PROJECT: Temple Sinai

**RESPONSE TO COMMENTS
ON THE
UPDATE TO THE TECHNICAL DRAINAGE STUDY
FOR
TEMPLE SINAI**

CITY OF LAS VEGAS		DATE:
INTER-OFFICE MEMORANDUM		May 29, 2013
TO: Land Development Services Department of Public Works		FROM: Albert Sung, P.E. Flood Control Project Engineer Department of Public Works
SUBJECT:	COPIES TO:	
Drainage Study for:	G.C. Wallace Companies	
Temple Sinai	Temple Sinai of Las Vegas	
Cross Streets:	Hillpointe Road & Pinewood Hills Drive	Bart Anderson, P.E., DevCo
File Number:	F:\Depot\DSMemos\DS4601A.doc	
Parcel Number:	138-20-212-002	
Zoning Action:	CRG-xxxxx; SDR-xxxxx	
FEMA Flood Zone	YES	NO X
Proposed Storm Drain	YES	NO X

**Re: Response to Comments on the Technical Drainage Study for Temple Sinai
DS4601A**

MARK D. LEVIN, AIA
TEMPLE SINAI
FIGURE 1AR - PROPOSED CONDITIONS
ONSITE DRAINAGE BASIN MAP (1 of 2)

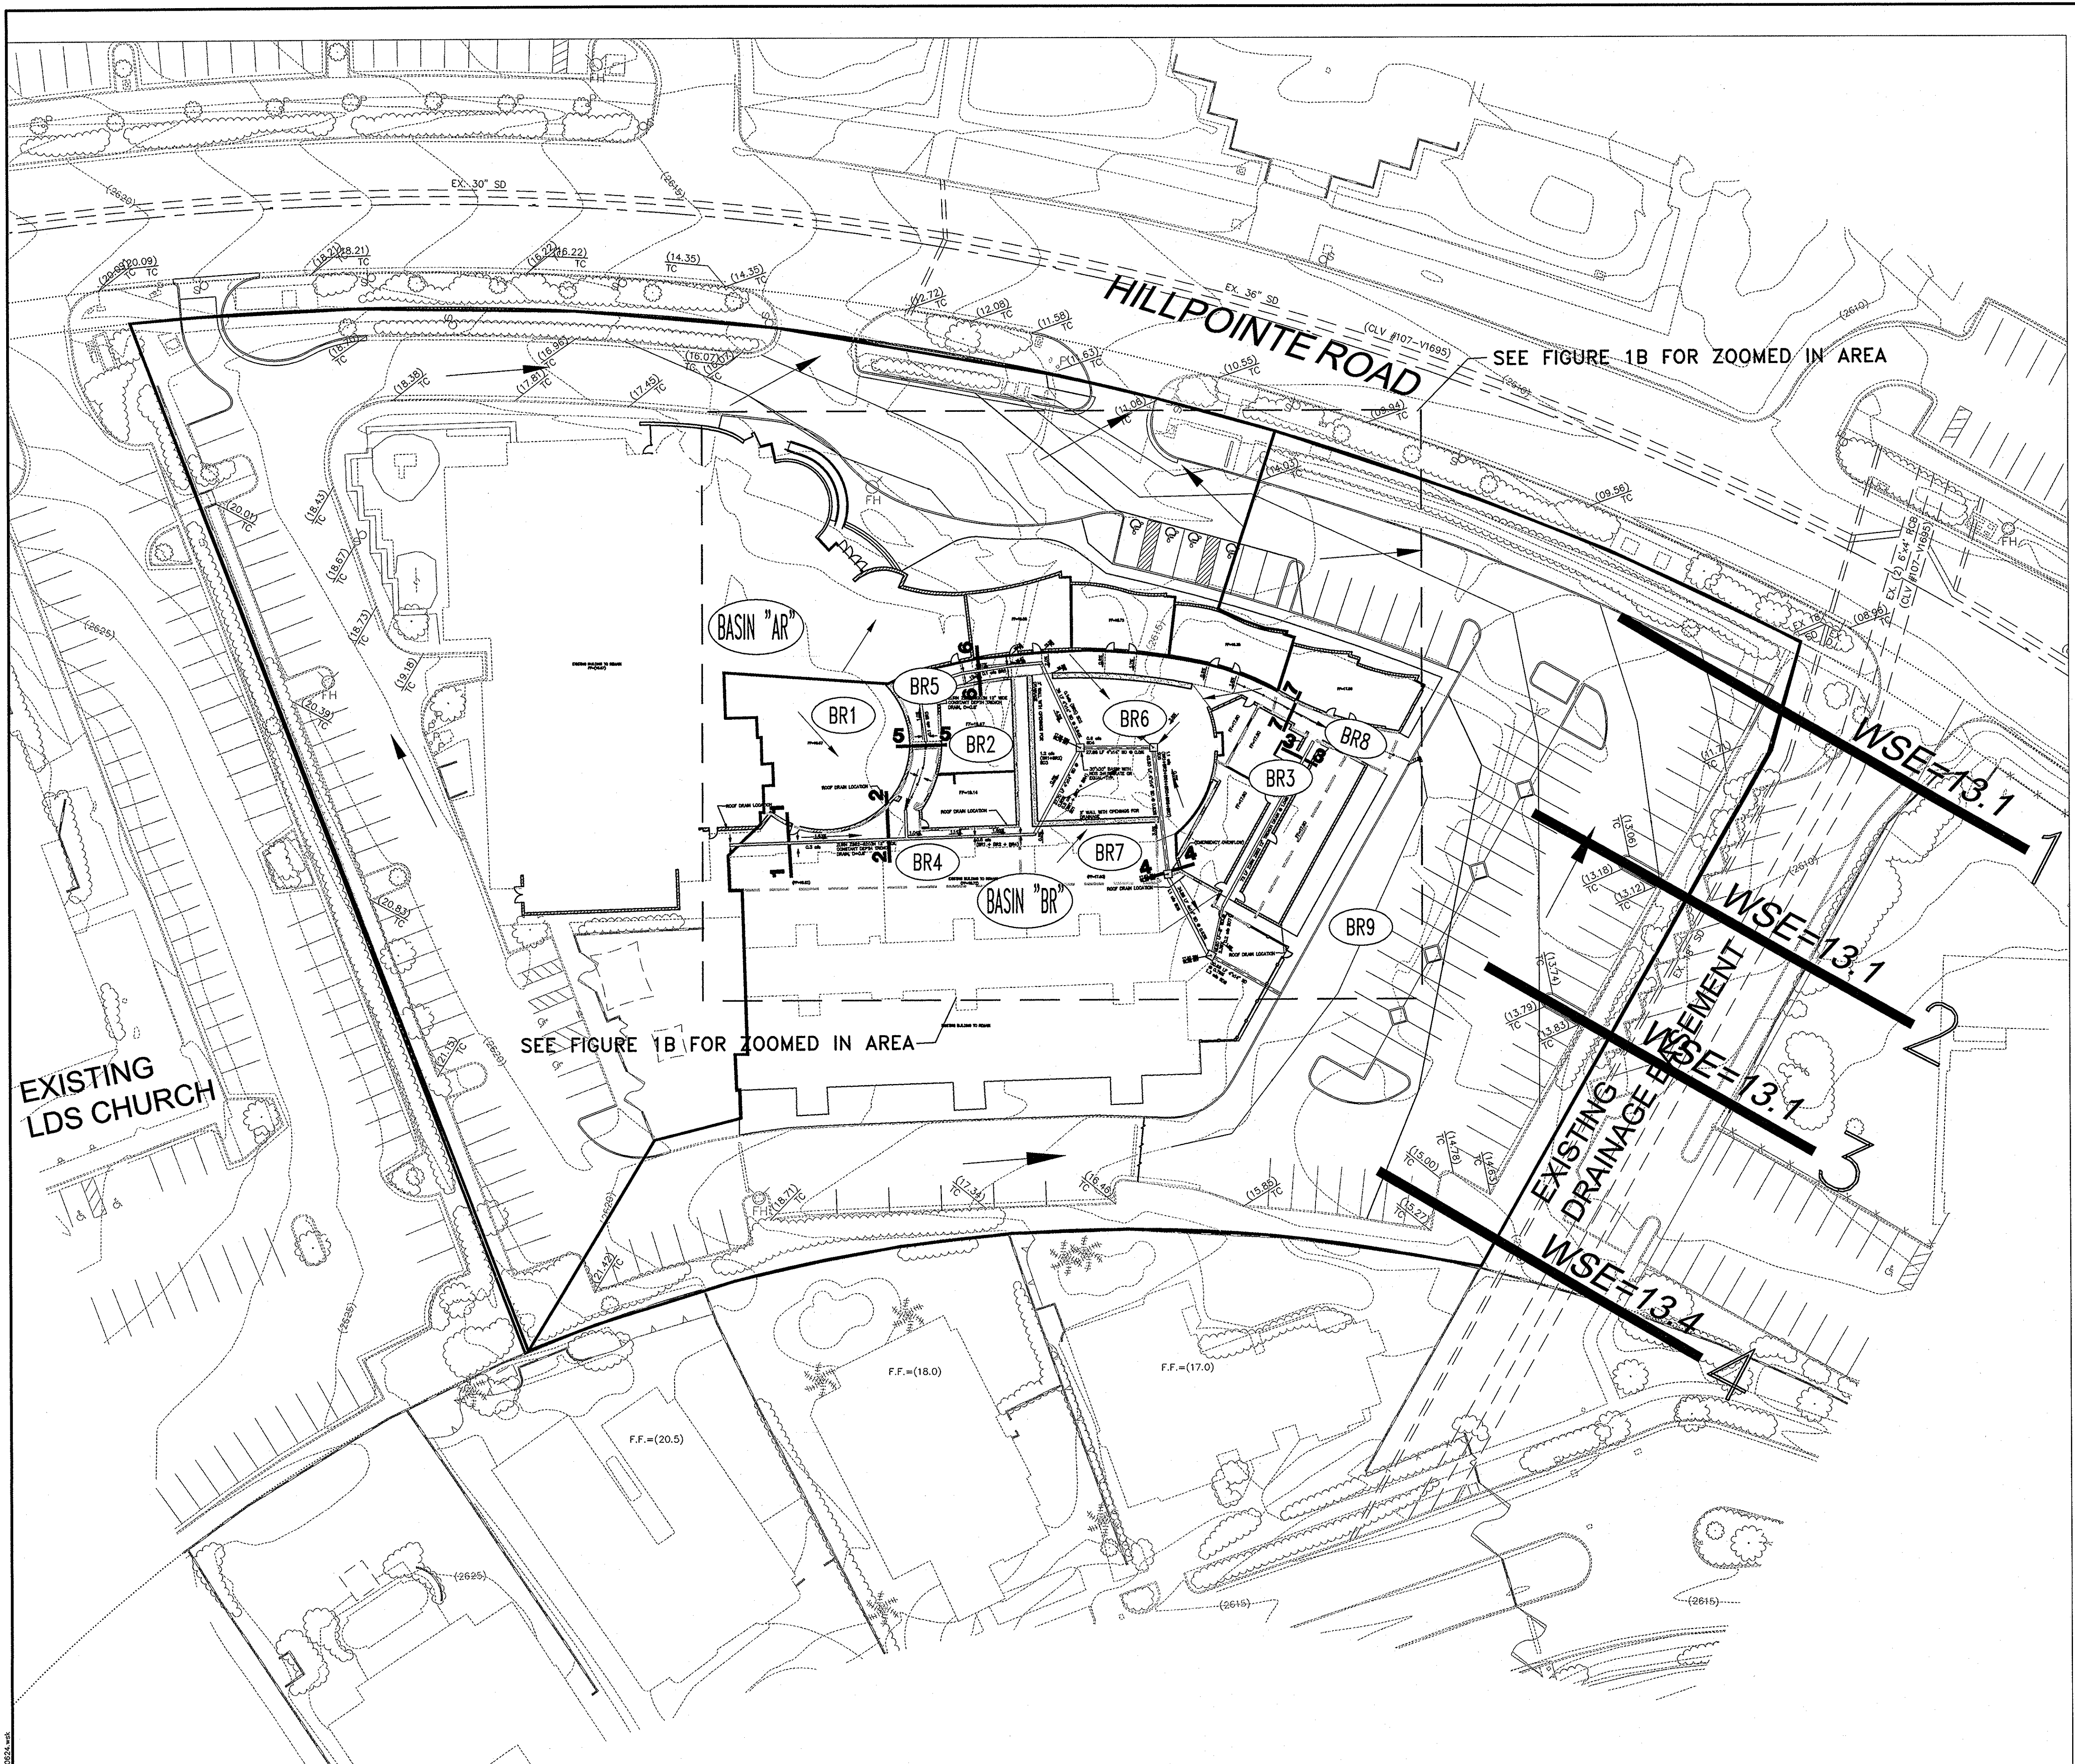
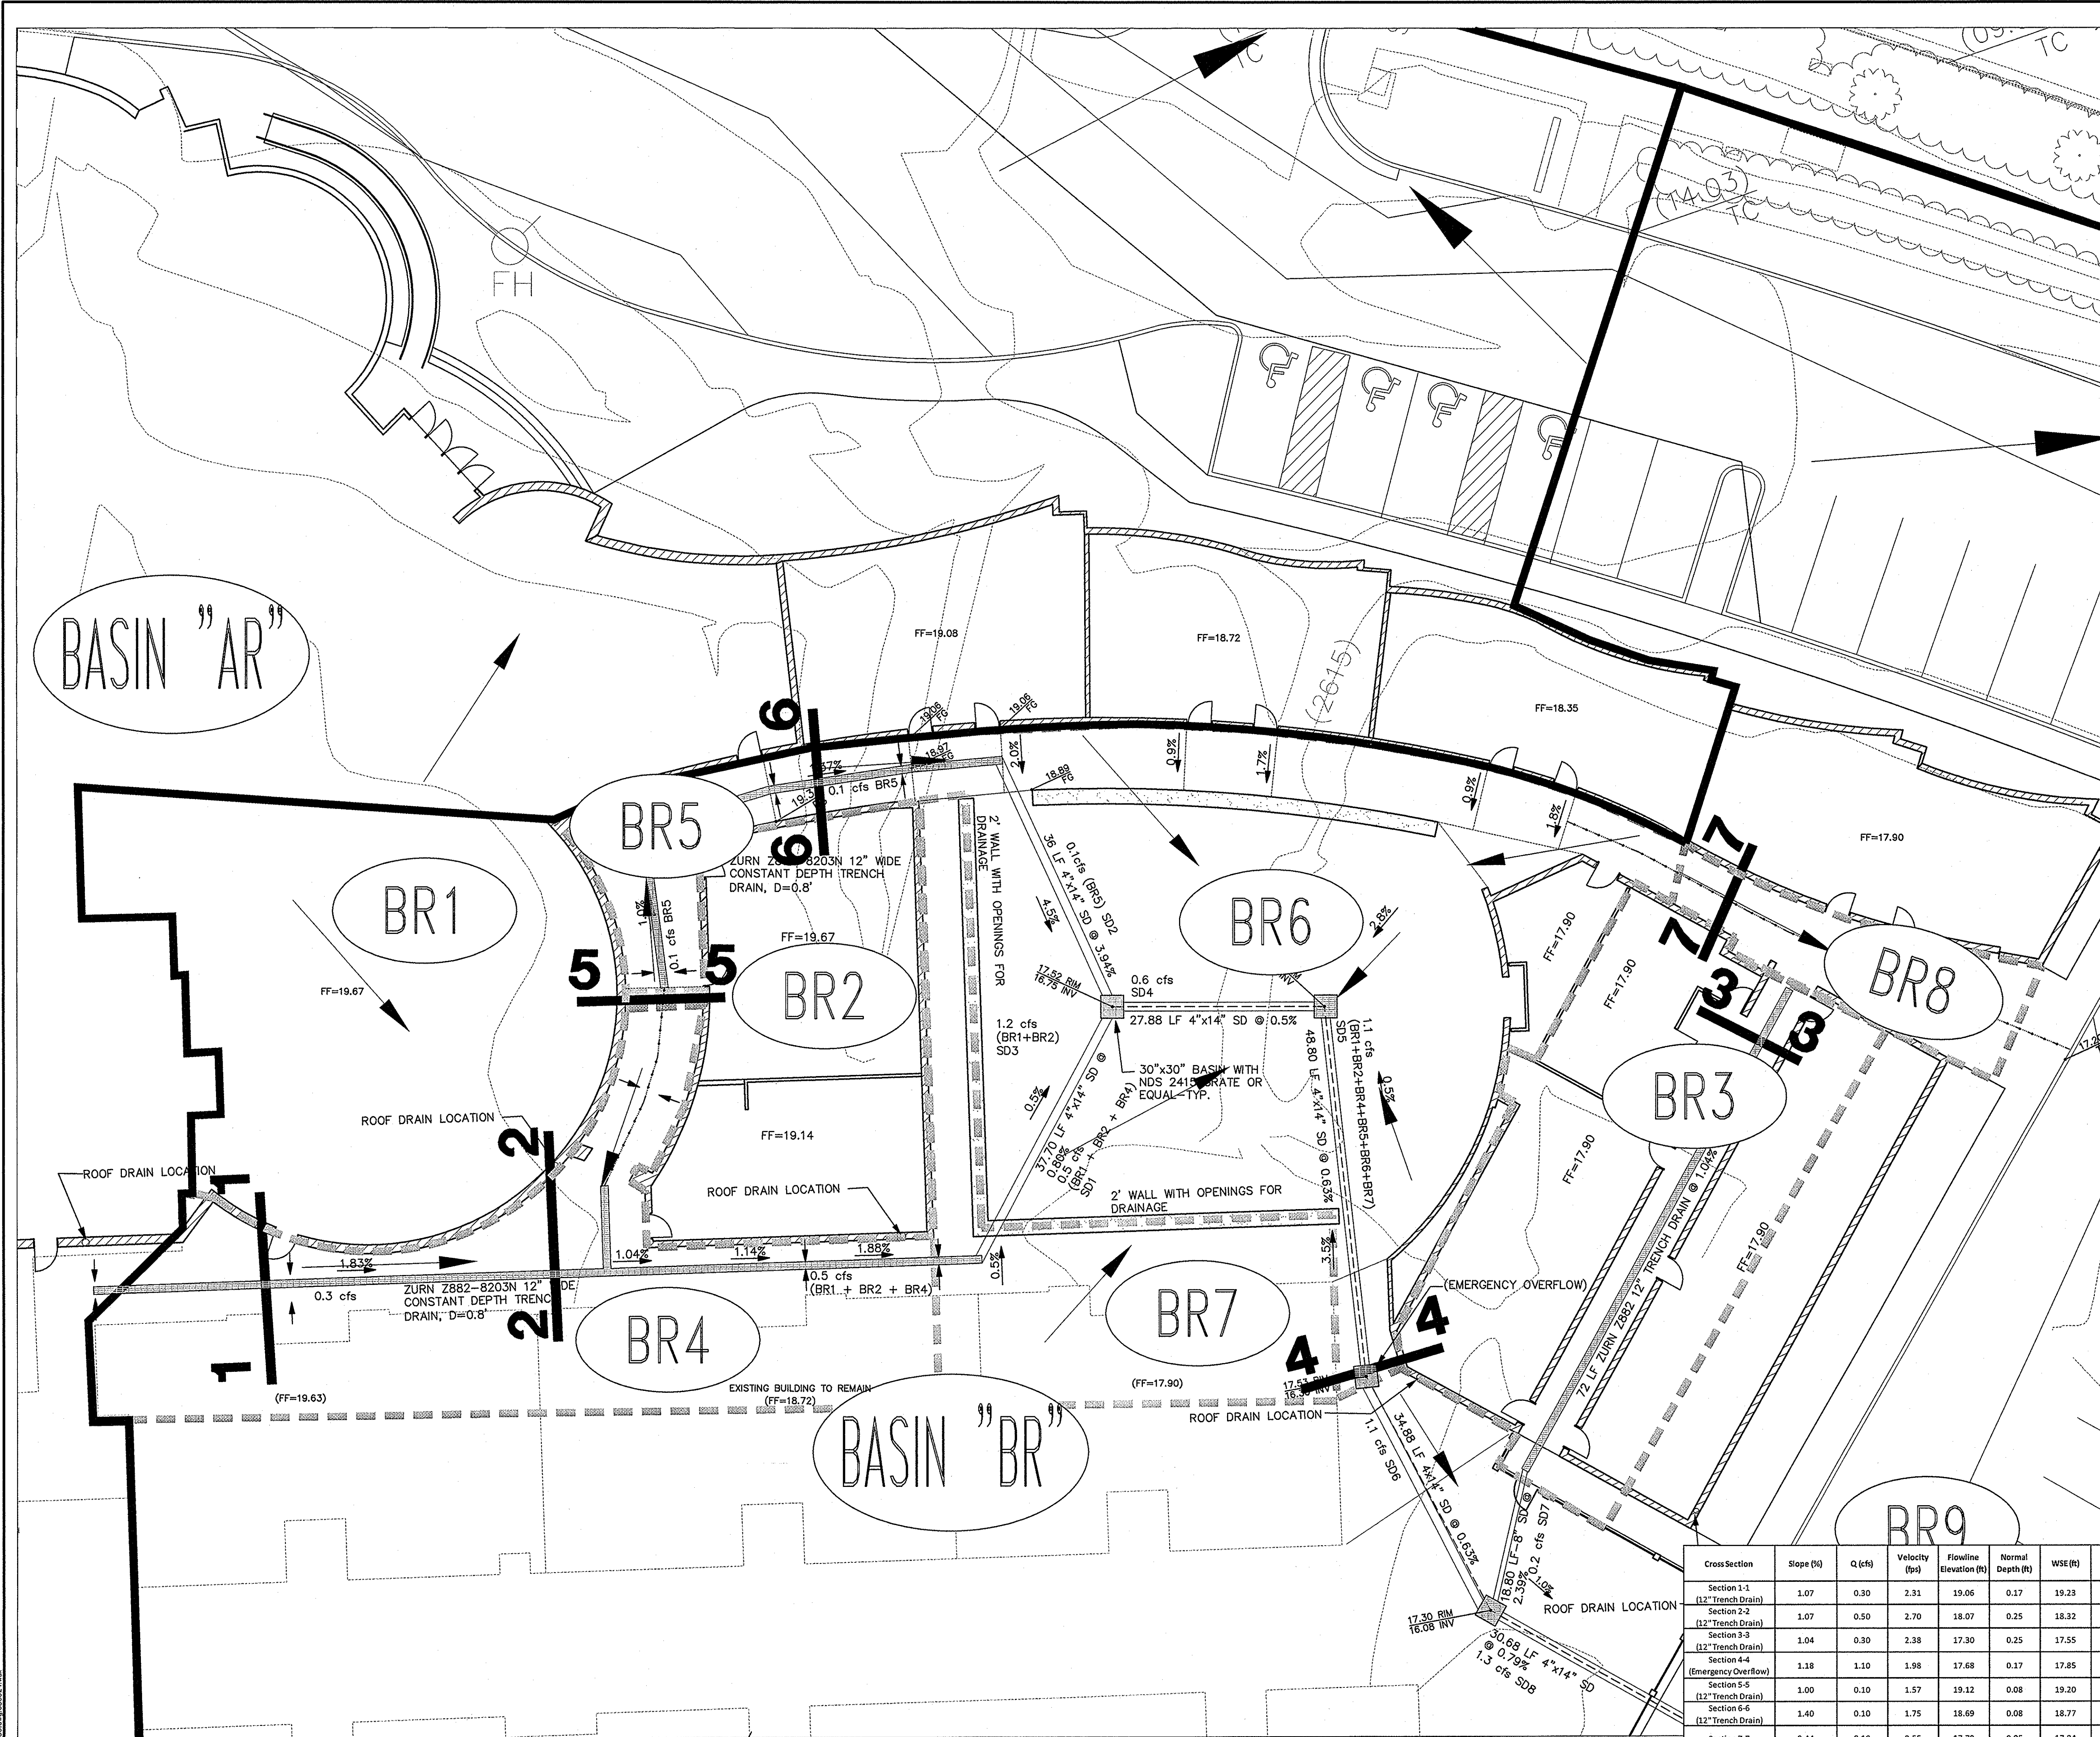
Comment: "3. A storm drain is proposed through and under a new building in the courtyard area which is not allowed in the *City of Las Vegas*. Review and re-route the drain in the next submittal."

Subbasins AR and BR have been revised to reflect the current roof drain plan for the proposed building expansion. Please see revised Figures 1AR and 1BR in the Appendix. Approximately

0.07 acres of the proposed building expansion is included in Subbasin BR. The remaining 0.15 acres of the proposed building expansion has been added to Subbasin AR. The proposed conditions hydrologic model and supporting calculations have been revised to reflect the revised subbasin areas. The HEC-1 summary and prorated flow summary tables have been updated on Figures 1A and 1B. The total flow generated onsite will be 14 cfs during proposed conditions.
